Pricing Narrative

August 31, 2026

Broad Creek Apartments
Hilton Head Island, SC
60% Plans Working Budget
Pricing Narrative

Very Rough sketch of temporary access roads for Condo Residents initial Construction

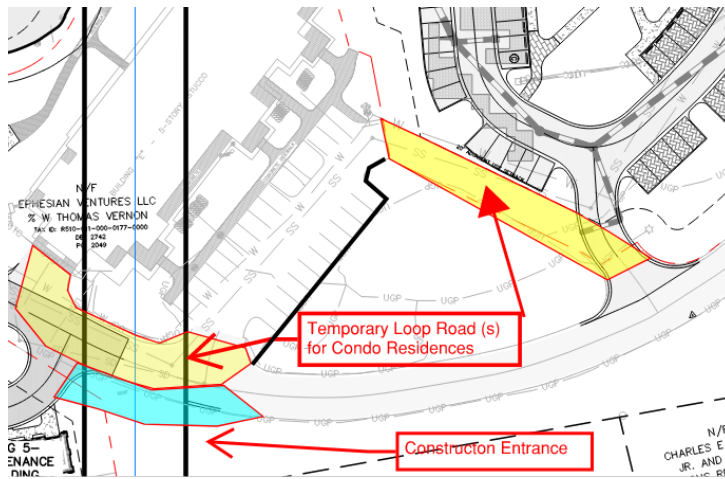
The advantage is the existing residents can come and go closer to the main site entrance gates, further away from the construction entrance at B2. Temporary gates and fences will be put across their current drive entrances which can be opened for First Responders as necessary. We ran this thought by Ward Edwards and they liked the idea and did not think this had to be part of the SWPPP plan, but maybe discussed with ToHHI Traffic Control.

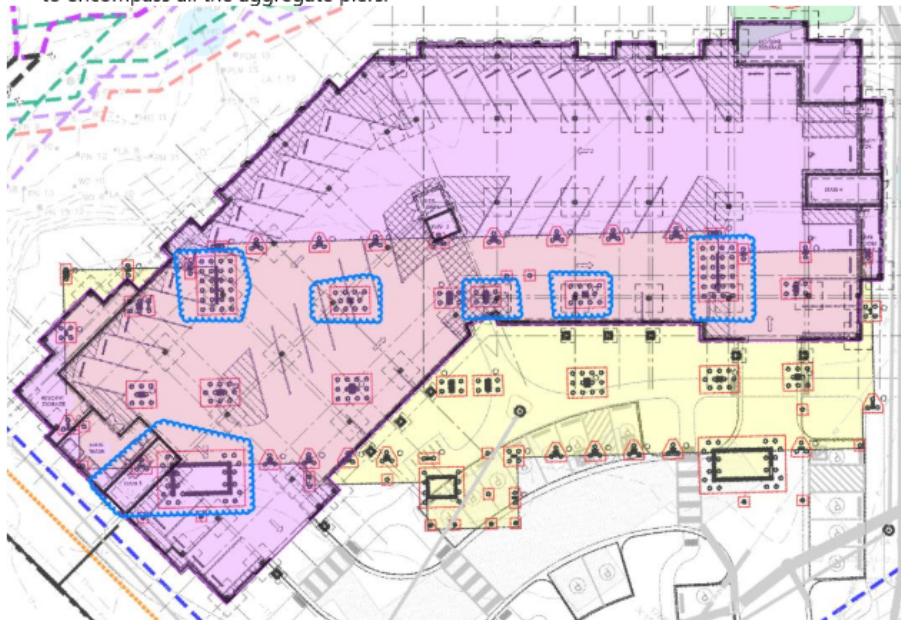
- a. Regarding Building 2 existing piles, the game plan is to demolish the existing piles down -5 feet and install the agg piers between and around them, adding #57 stone across the tops of existing piles to take advantage of any support they offer, without relying on them. This may require the foundations at these locations to increase somewhat, as determined by SCG. We have allowed for modest increase in these foundations. See below for specific areas of concern:

- b. See Sketch for further explanation:
 - WBG was notified that Building 2 will have existing pile foundations left in place from the current structure. The pile caps will need to be removed, and the piles themselves will need to be cut several feet from bottom of footing. WBG has identified the following foundations (clouded in blue) that will require aggregate piers to be shifted around the existing piles. With some aggregate piers being shifted, some resizing of the foundations will be required in order to encompass all the aggregate piers.

- There are multiple foundations with negative live loads shown. Clarification needs to be provided on if any uplift resistance will be needed.
- c. Pile Surveying & Monitoring included.
